Fault message in instrument cluster "Additional Battery - Service Required" - FC B11C11B

Topic number	LI54.10-P-058943
Version	5
Design group	54.10 Battery, voltage supply, voltage converter
Date	10-15-2014
Validity	W166 with SA code "B03" ECO start/stop up to VIN end no. A486472 X166 with SA code "B03" ECO start/stop up to VIN end no. A486532 BR463 with SA code "MJ7" ECO start/stop as of XZ2 (Model year 2013) up to VIN end no. X228261
Reason for change	Validity for W/X 166 adjusted; W166 with SA code "B03" ECO start/stop up to VIN end no. A486472; X166 with SA code "B03" ECO start/stop up to VIN end no. A486532
Reason for block

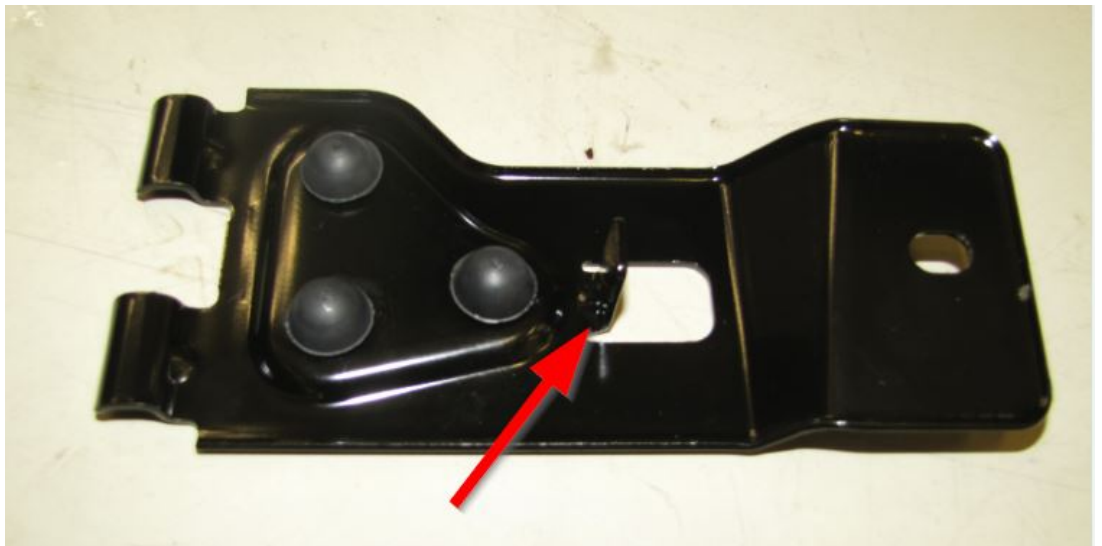
When installing object number A0009829308 on BR166, the retaining lug on the battery bracket must be bent upwards by 90° as described in attachment "2".
